## Response to anonymous Referee #1

### Interactive comment on “Building Asset Value Mapping in Support of Flood Risk Assessment: A Case Study of Shanghai, China” by Jidong Wu et al.

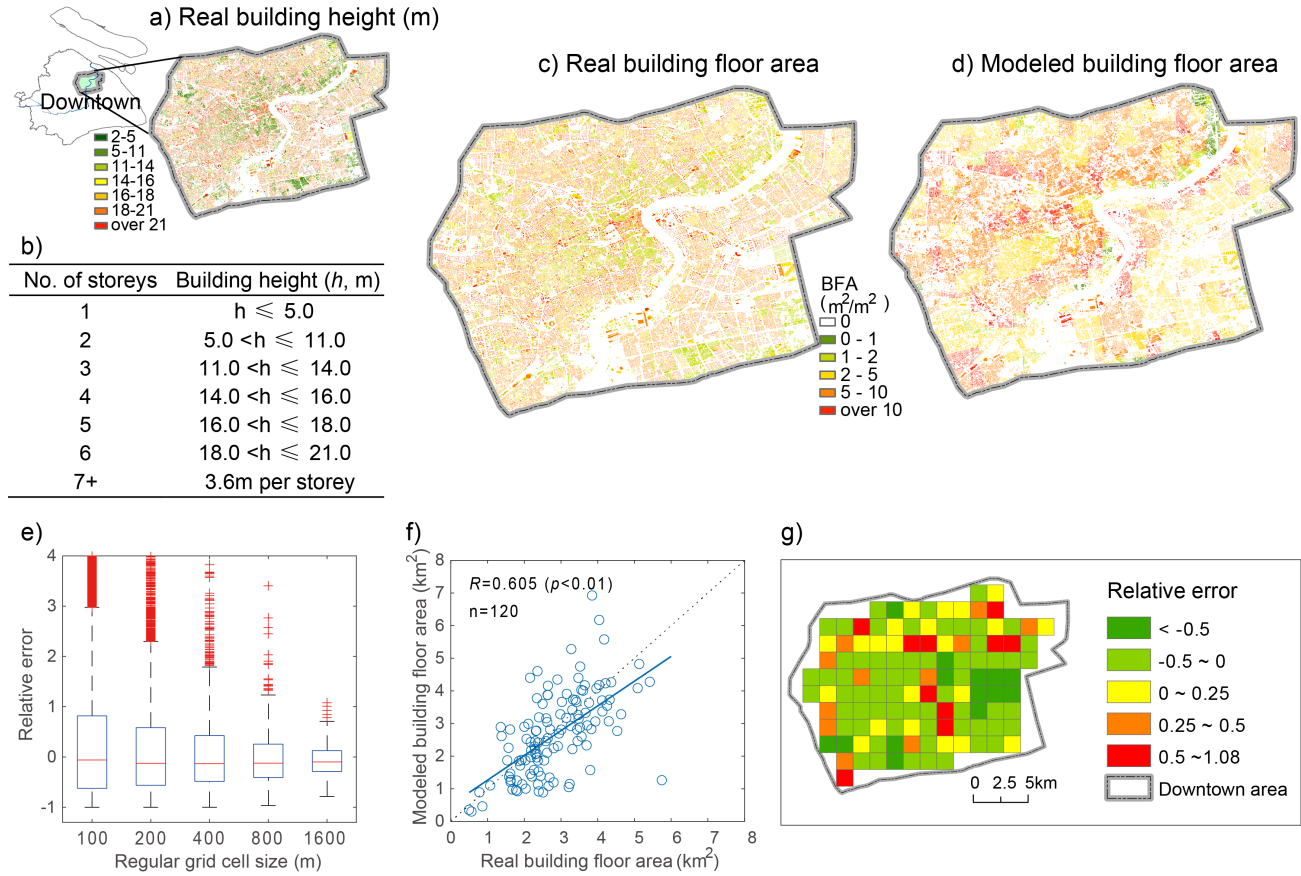
2): While the floor area and population are generally closely related and high correlation between them in district level has been presented, to use population data as proxy to estimate the building density can still bring major errors in some areas of Chinese city, such as villa residential and ‘village in the city’. For these areas, the building density for the same number of population should be totally different. For these part, **a correlation analysis with validation with random point instead of district level should be necessary**, especially taking account for the high-resolution results in this research (P5, L15\_20);

**Response:** Thanks for your constructive comments. As you referred, the population density is not perfectly correlated with building area, such as villa residential and ‘village in the city’, the spatial heterogeneity for this correlation should be even bigger in finer spatial scale. We totally agree with your suggestion, and did a finer spatial scale validation: firstly, we acquired a real building distribution vector layer for downtown area of Shanghai, which including the building height information, according to the relationship between number of storeys and building height sampling, we transformed building height to building storeys, then we can calculate building floor area in each regular grid cell; b) after that, we can compare the modeled building floor area with the real building floor area as you suggested and as a necessary supplement of validation except for district level correlation analysis.

Detailed revisions are as follows: 1) we add a new figure in the main text (Section 3) to show the validation of modeled building floor area in the downtown area of Shanghai. 2) we add a paragraph to describe the validation process and results in the new Section 3.2. “As population density is not fully correlated with BFA, such as villa residential and ‘village in the city’ in some city of China, for further validating the accuracy of modeled BFA in sub-district level, we compared the modeled BFA with real BFA. As Figure 6 shows, .....”
